Blanchardstown to City Centre Core Bus Corridor Scheme Submission (Ref. No. 313892)

Submitted on Behalf of:
Kevin Lawler
1 Herbert Road, Blanchardstown, Dublin 15

30th August 2022

Figure 3.0 Extracts from Sheet 10 of the General Arrangement drawing illustrating the proposed works relative to our client's site (purple fill).

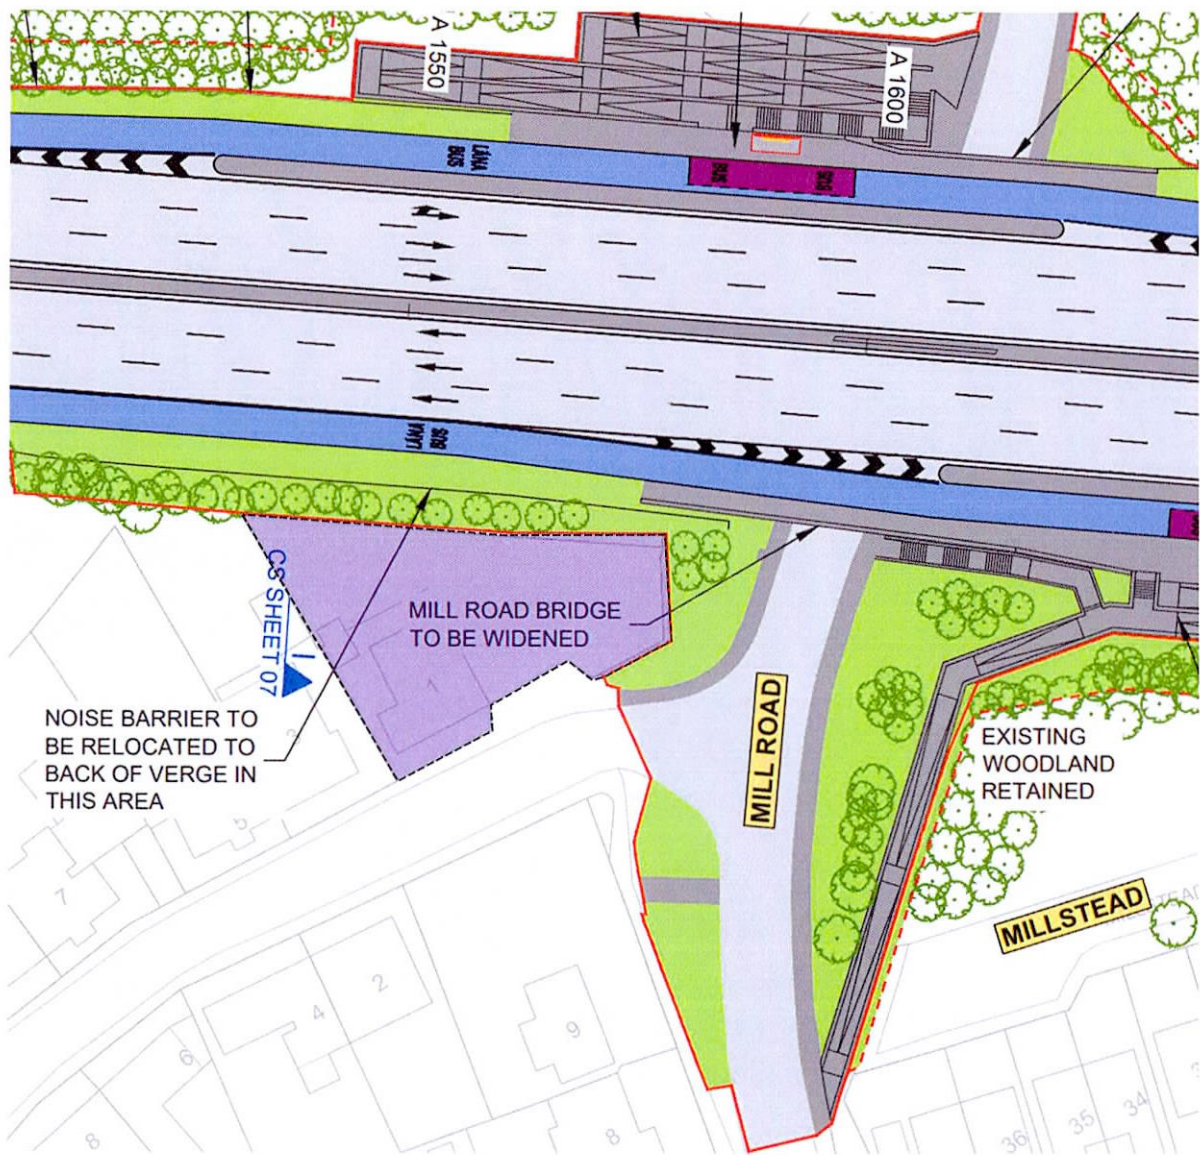
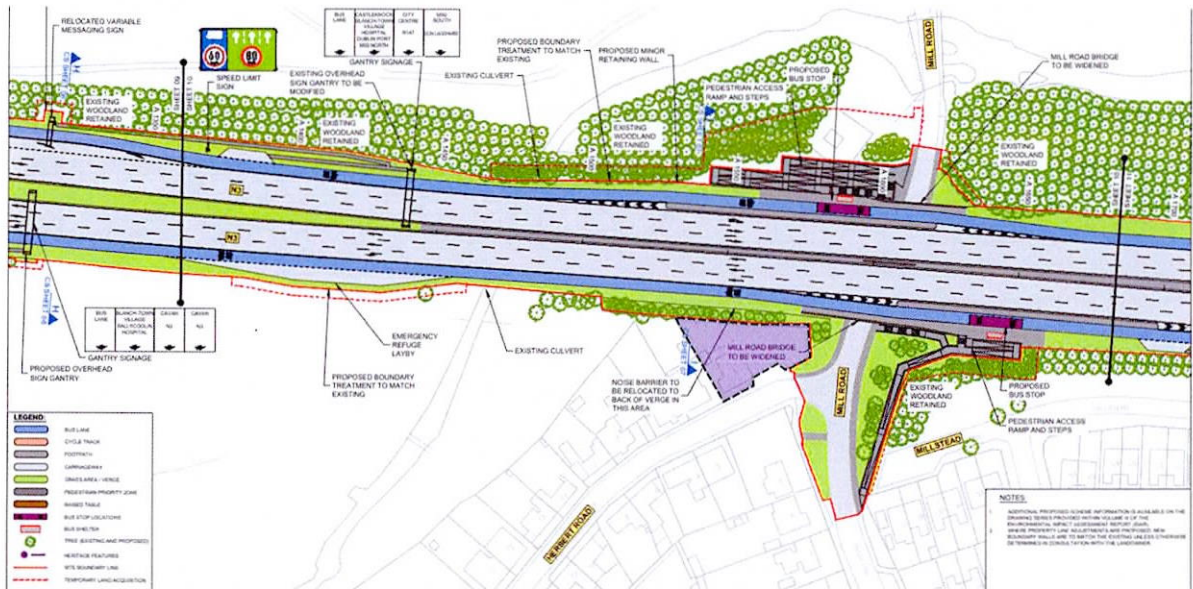
As per the documentation available at <https://blanchardstownscheme.ie/>, the Blanchardstown to City Centre Core Bus Corridor Scheme proposes the construction of a new bus lane adjoining the existing three-lane roadway operating along the N3 to the immediate north of our client's site.

This bus lane will be partially accommodated within the existing grass verge adjoining the roadway but will necessitate the further building up, reinforcement and stabilisation of the steep bank to the rear of our client's site and the provision of a new grassed verge. Associated finishing works, including the installation of a new noise barrier and the removal/planting of new vegetation will necessitate the further expansion of the land bank.

Additional works within the immediate area will comprise the extension of the existing support bridge to accommodate the new bus lane and the provision of a new bus stop on the N3 with associated pedestrian ramp/steps to Mill Road.

Figure 7.0 Images illustrating existing light pollution into our client's site. This pollution will be exacerbated by the relocation of boundary treatments and vegetation to the detriment of our client's amenity.

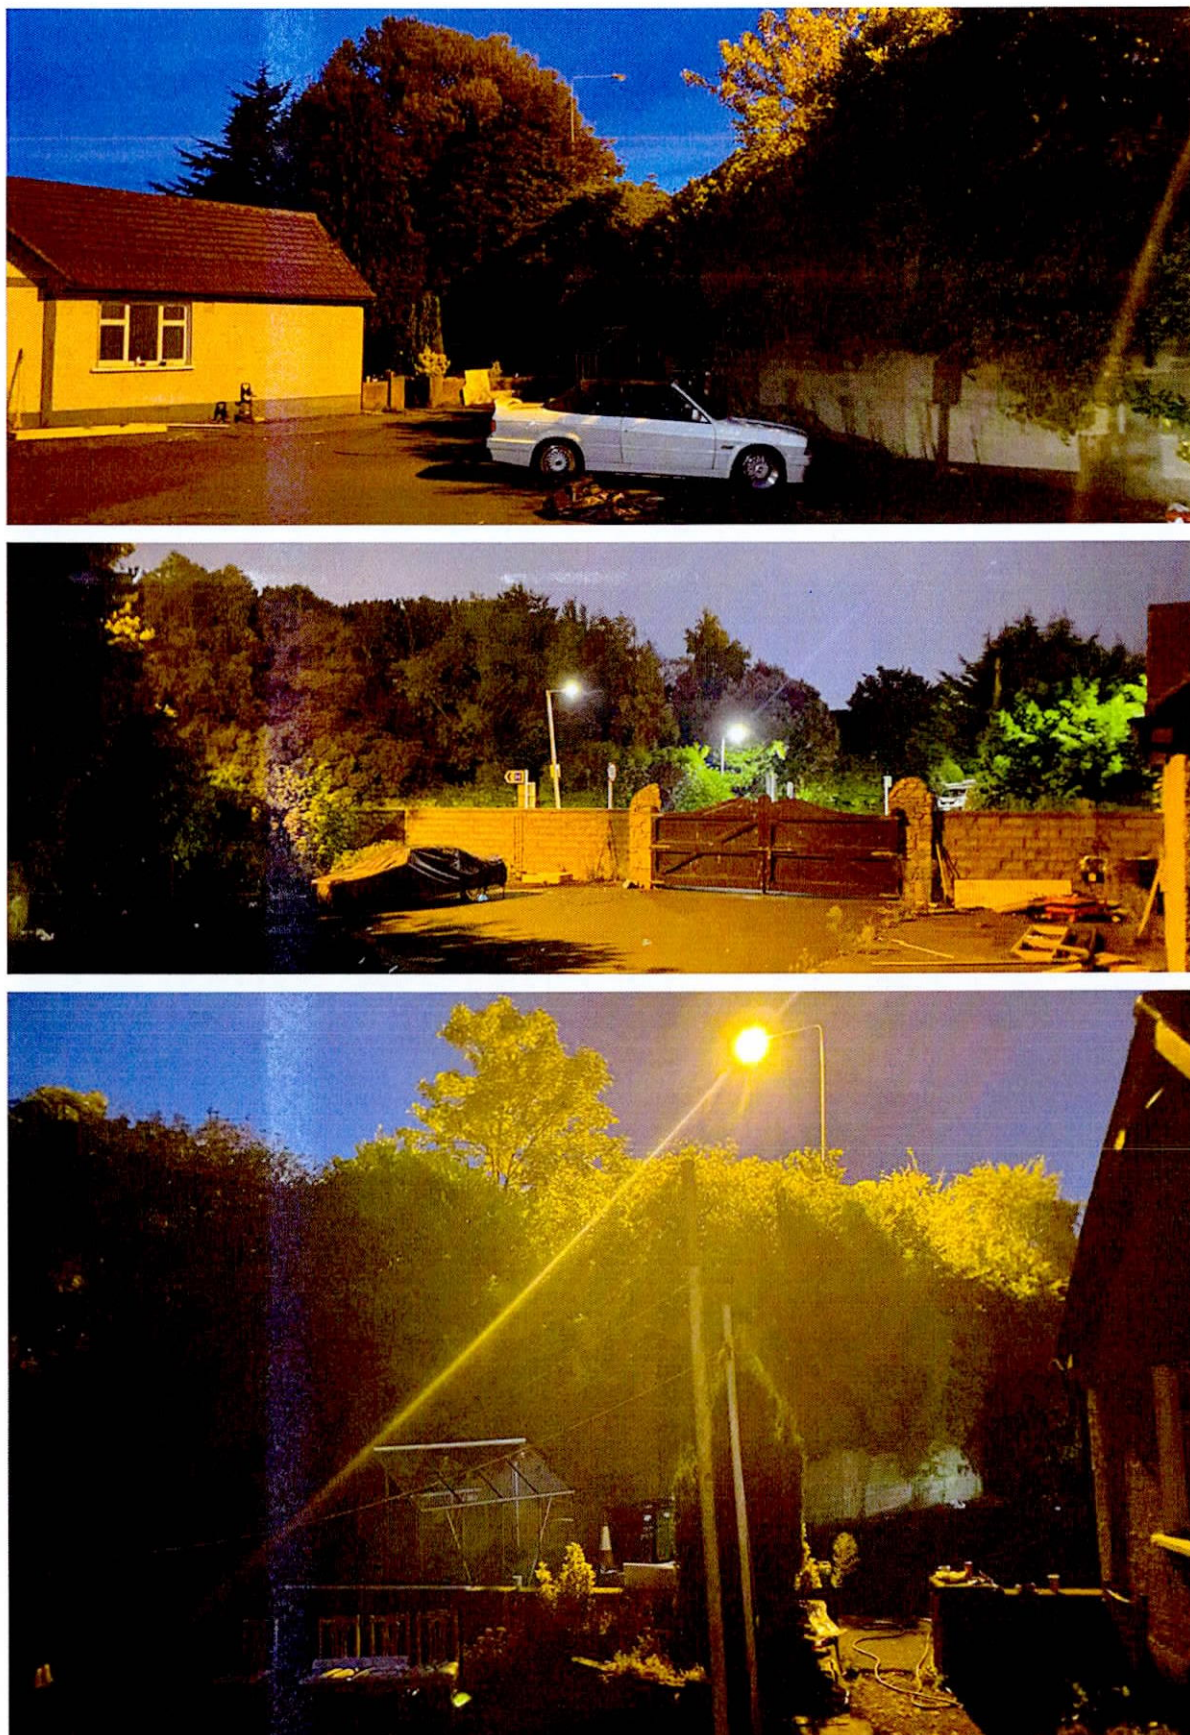
Whilst we note no change in the quantum/type of street lighting infrastructure within the immediate vicinity of our client’s site, it is submitted that this property will be impacted by severe light pollution in the interim period between the removal of existing vegetation and the planting/growth of replacement vegetation to mature stage where it can again provide similar screening from lighting on the N3 roadway. The resulting light pollution will be a nuisance to all surrounding properties and could prove detrimental to local wildlife.

In similar manner to the above conclusion in relation to noise impacts, it is considered that the extent of light pollution arising as a result of the necessary works could compromise the health and wellbeing of our client and we would ask that this be taken into account.
